Addendum #1

For Plumbing Renewal at Sainte-Jeanne-d'Arc

MECHANICAL ADDENDUM

ADDENDUM No. 1

SKM-1

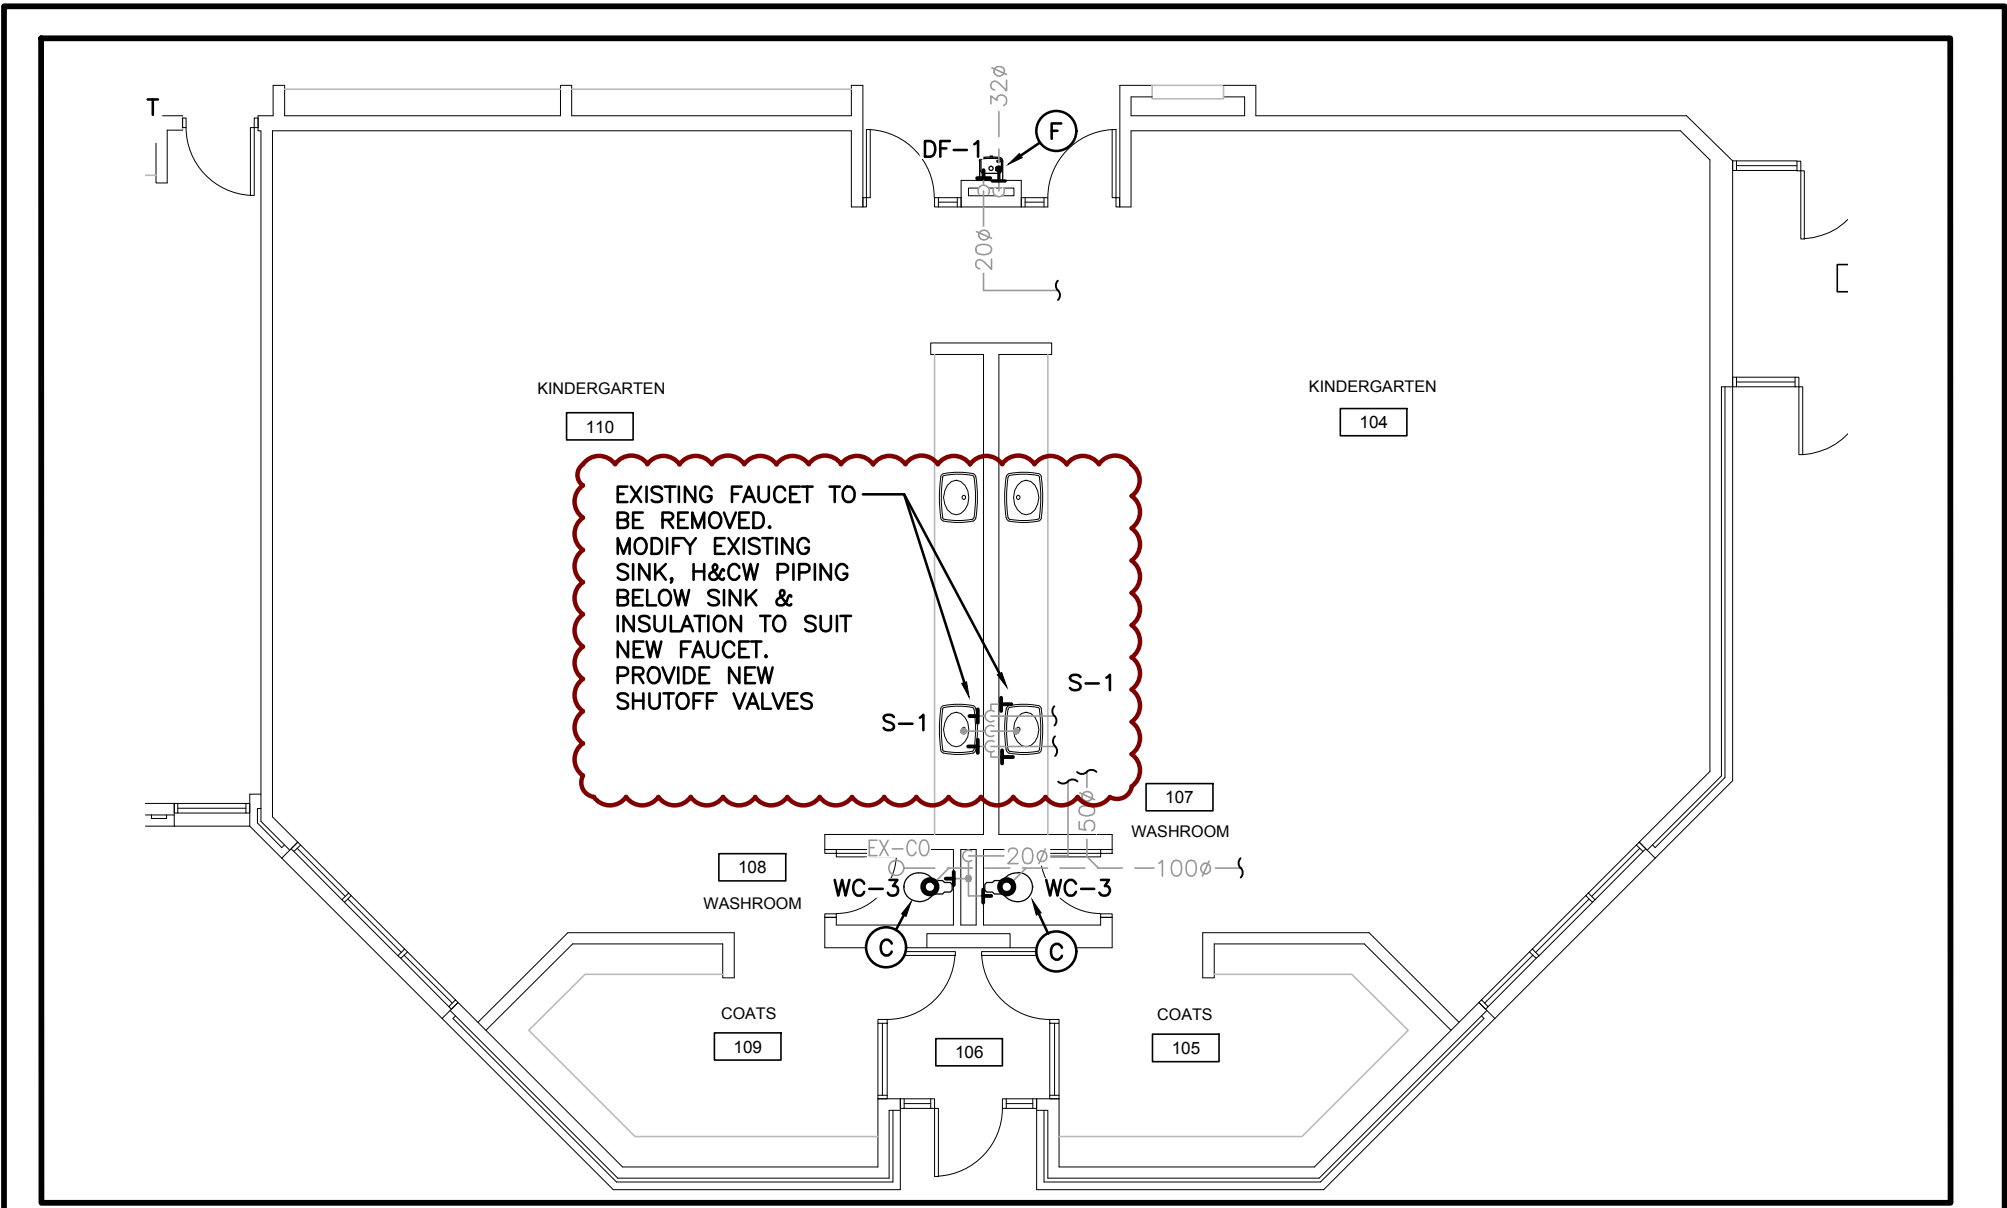
1.0 Reference Drawing ME3-1 and Attached Sketch SKM-1

.1 In Kindergarten 104 and Kindergarten 110, on the low sink remove the existing faucet, provide new shut offs below the sink, reinsulate piping, modify the sink and modify piping to suit new faucet. Provide new as follows:

“.1 Faucet: chrome plated brass, with swing spout, aerator, single opening, accessories to limit flow rate to 8.35 litres/minute (2.2 gpm) at 413 kPa (60 psi).

.2 Acceptable materials:
Moen 8280-S0030-52603”

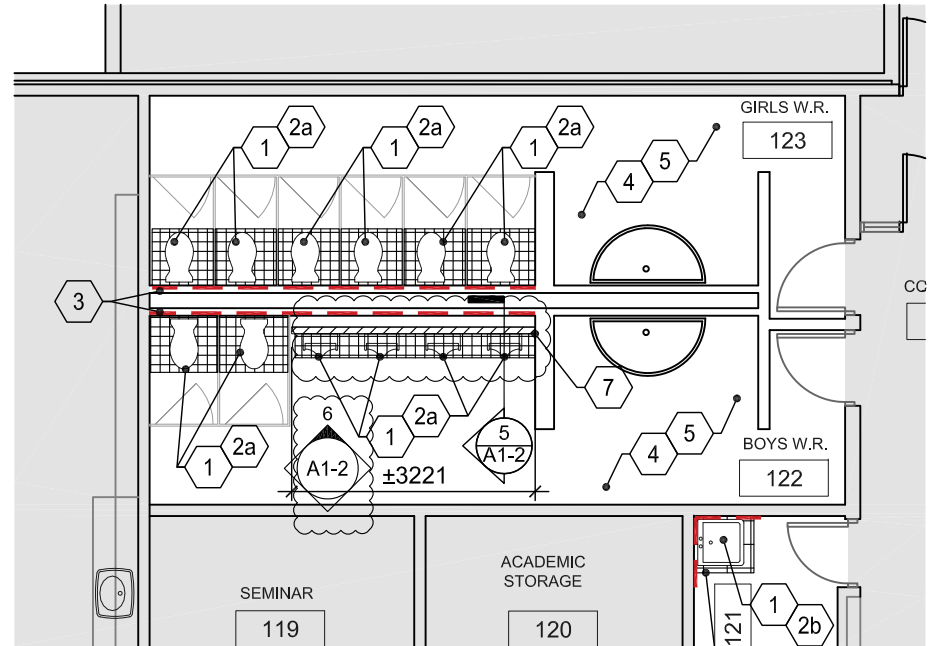
6	Refer to attached dwg ADD-01 – it clarifies mounting height of urinals and extent of flooring replacement at urinals
